STAFF REPORT

SUBJECT: FP-2021-0043
Pura Vida Ridge Ranch No. 1

Final plat consisting of 58 buildable lots and 13 common lots on 7.63-acres of land in the R-15 zoning district for the first phase of Pura Vida Ridge Ranch Subdivision.

B. Final Plat (date: 7/30/2021)

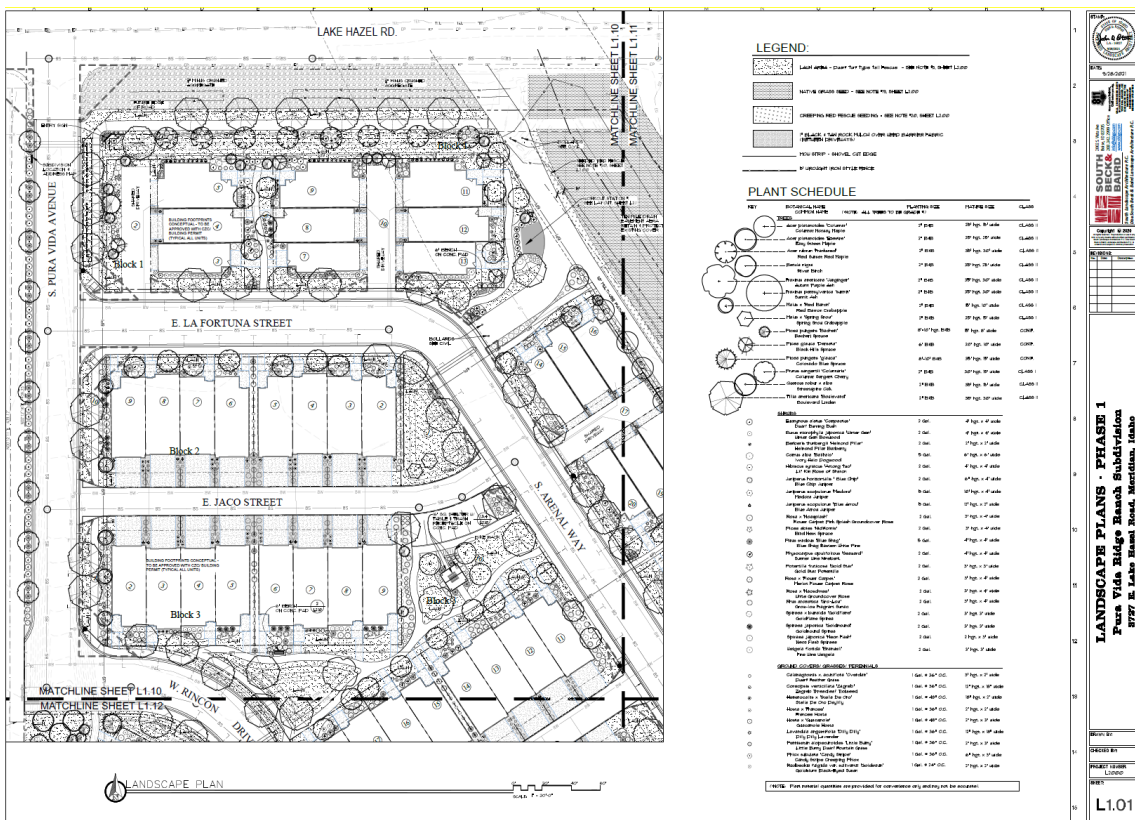
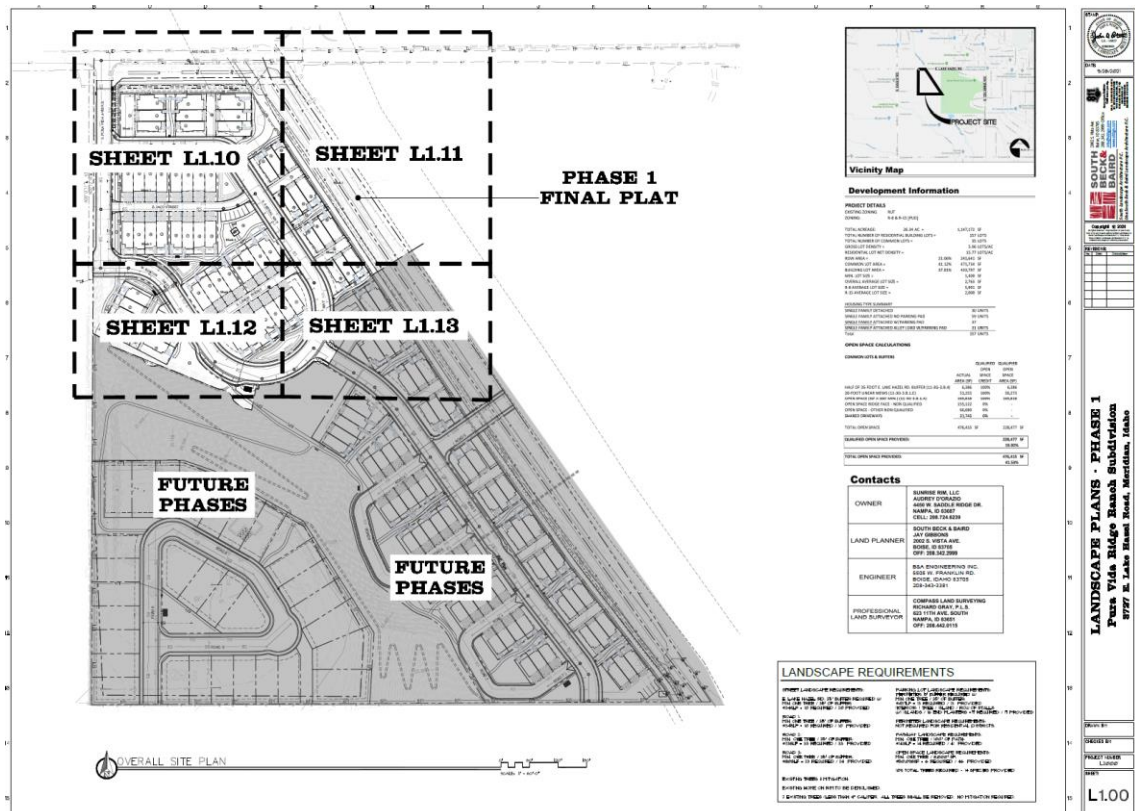
- a. Include recorded instrument number of existing storm drainage maintenance easement.

- b. Note #6: ". . . in compliance with ~~H-2019-0058~~ H-2020-0064."
- c. Note #9: ". . . prior approval from the health authority and the City of Meridian."
- d. Note #16: Include date and recorded instrument numbers for the ACHD storm water drainage system.

- e. The minimum property size in the R-15 zoning district is 2,000 square feet per UDC Table 11-2A-7; revise Lots 4, 8, 12, 15, 16, 18, 19, 23, 24, 26, and 27, Block 1 and Lots 2, 3 and 7, Block 5 to comply.
- f. Correct the number of buildable/open space lots in the Purpose of the Survey Narrative.
- g. Include a curve reference # for the south end of Lot 10, Block 1.

C. Landscape Plan (date: 9/28/2021)

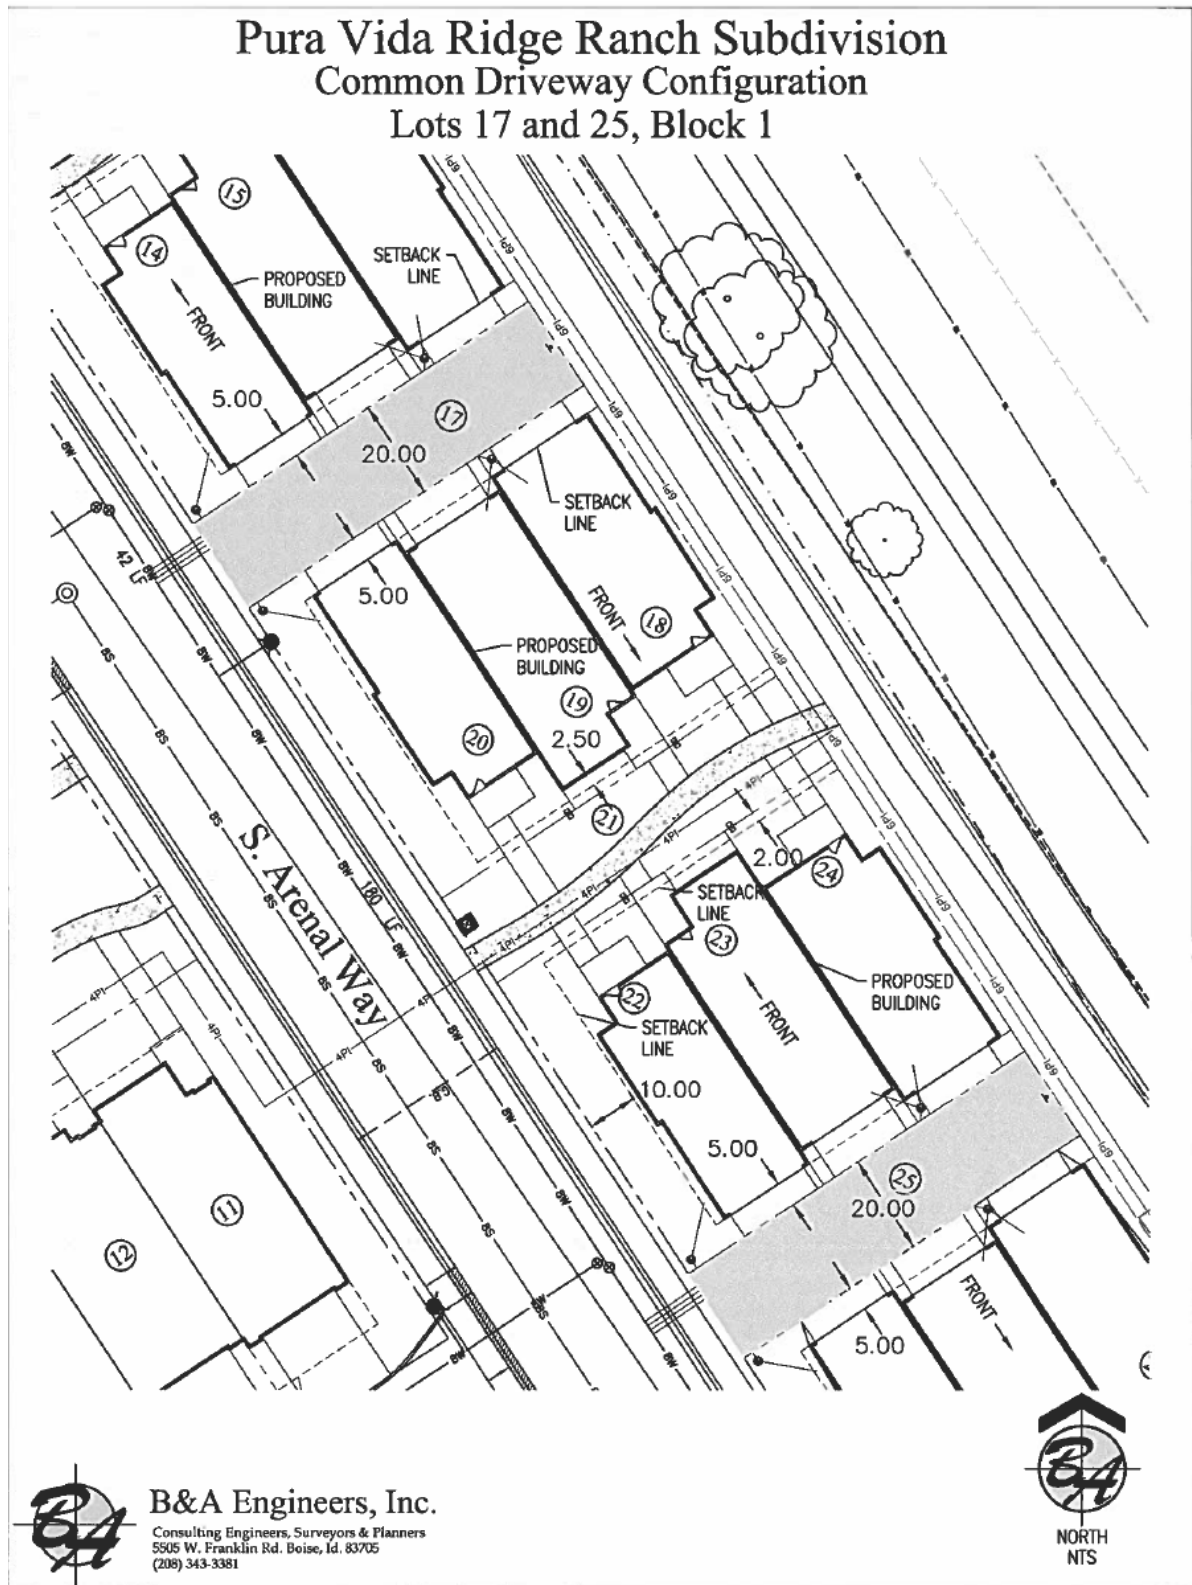
5. The landscape plan shown in Section V.C, prepared by South Beck & Baird, dated 9/28/21, shall be revised as follows:
 - a. The pathway encroaches on the corner of Lot 13, Block 1; relocate the pathway outside of the buildable lot.
 - b. Depict fencing abutting pathways and common open space lots to distinguish common from private areas per the standards listed in UDC 11-3A-7A.7; include a detail(s) of the proposed fence. *Note: This section of Code is eligible for alternative compliance.*

D. Common Driveway Exhibits

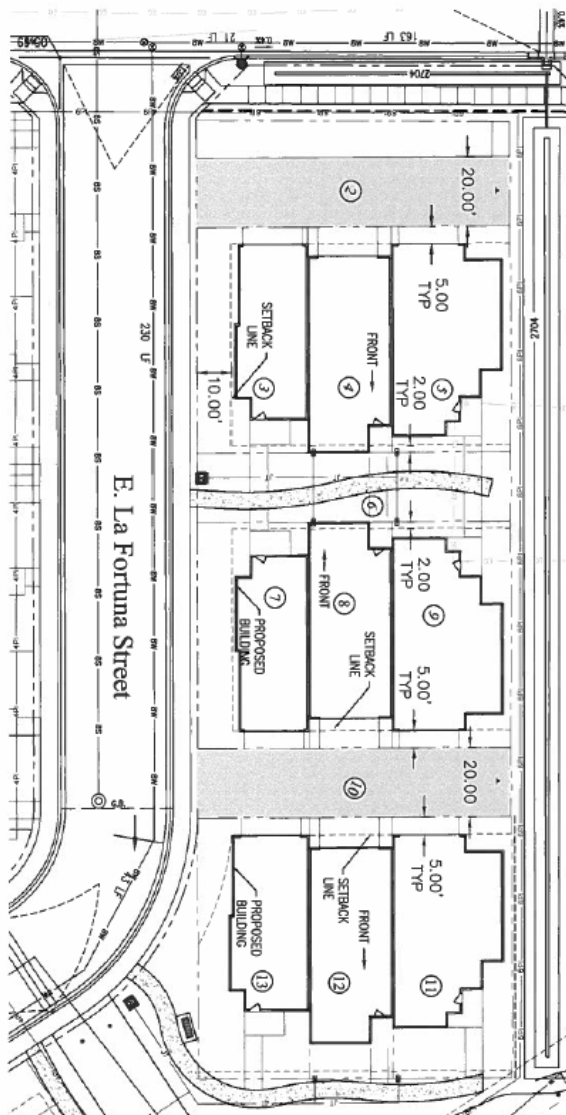
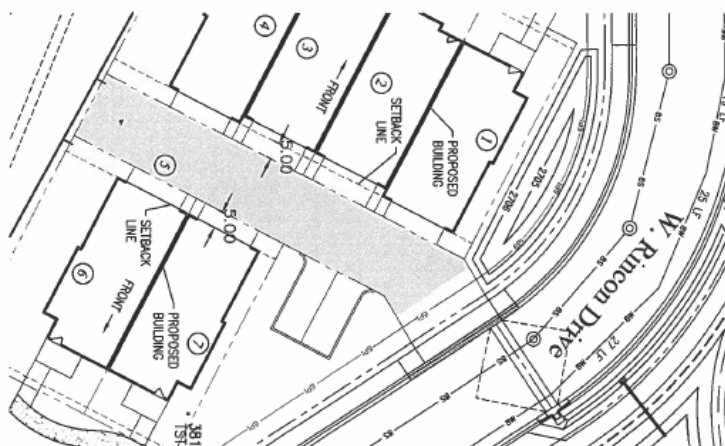
7. Development of Lots 3-5, 7-9, 11-13, 14-16, 18-20, 22-24 and 26-28, Block 1 and Lots 1-4 and 7-8, Block 5 shall comply with the setbacks depicts on the common driveway exhibits in Section V.D and as approved with the Planned Unit Development (H-2020-0064).
